Access Compliance Report

Public Rights-of-Way

(Curb Ramps)

Intersection ID: 29142	Main Street: APPLEDALE_DR	Cross Street: BRIDGEVILLE_LN	Location: SW
ADA ID: 6293FA624ED9	Ramp Type: BlendTrans1	Initial Pass/Fail: Fail	Overall Compliance: No
Severity Score: 12.5			
Codes/Mitigation Info/Possible Solution		Field Measurements/Component Compliance

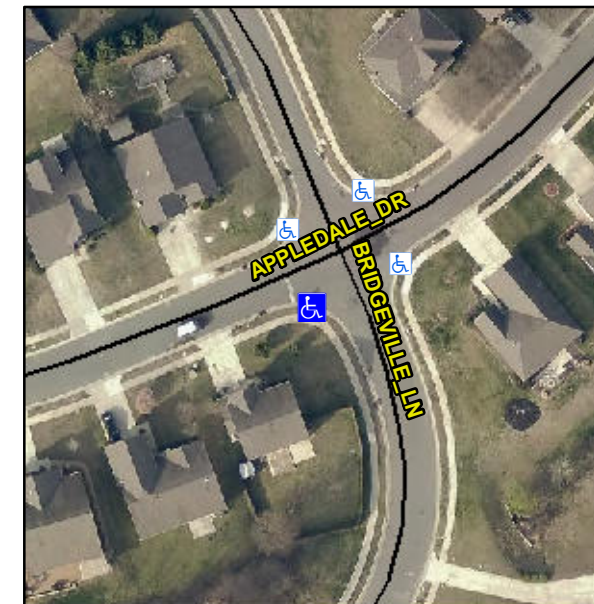
Not Found, R304.5.3

Compliance	Description	Data	Compliance	Description	Data
N/A	Ramp Length (in)	49.0	Yes	BlendTrans Slope (%)	3.4
Yes	Ramp Width (in)	159.0	No	BlendTrans XSlope (%)	5.6
N/A	Flare Type LT	N/A	N/A	Flare Type RT	N/A
N/A	Flare Slope LT (%)	N/A	N/A	Flare Slope RT (%)	N/A
N/A	Flare Traversable LT?	N/A	N/A	Flare Traversable RT?	N/A
N/A	Landing Length (in)	N/A	N/A	DWS Provided?	N/A
N/A	Landing Width (in)	N/A	N/A	DWS Contrast?	N/A
N/A	Landing Slope (%)	N/A	N/A	DWS Length (in)	N/A
N/A	Landing X Slope (%)	N/A	N/A	DWS Full Width?	N/A
N/A	Landing Curb? (Y/N)	N/A	N/A	DWS Offset (in)	N/A
N/A	Shared Landing?	N/A			
N/A	Gutter Ponding?	N/A	N/A	Gutter Slope (%)	N/A
N/A	Gutter Lip Ht (in)	N/A	N/A	Gutter X Slope (%)	N/A
N/A	Painted X Walk1?	No	N/A	Painted X Walk2?	No
	X Walk 1 Direction	To NE		X Walk 2 Direction	To N
	X Walk 1 Width (in)	N/A		X Walk 2 Width (in)	N/A
	X Walk 1 Slope (%)	5.6		X Walk 2 Slope (%)	3.4
	X Walk 1 X Slope (%)	7.4		X Walk 2 X Slope (%)	3.1

N/A	Ramp inside XWalk1?	N/A	N/A	Ramp inside XWalk2?	N/A
	Road Slope (%)	5.8		Clear Space?	N/A
	Road X Slope (%)	0.7	N/A	Clear Space to XWalk (in)	N/A
N/A	Any Obstructions?	N/A	N/A	Storm Grate/Utility Hazard?	N/A
	Obstruction Type			Storm Grate/Utility Type	
		N/A			N/A
		Yes		Surface Condition? (G/P)	Good
		No		Curb Slope (%)	9.3

Remove & Replace Curb Ramp With Two New Directional Ramps or Equivalent.
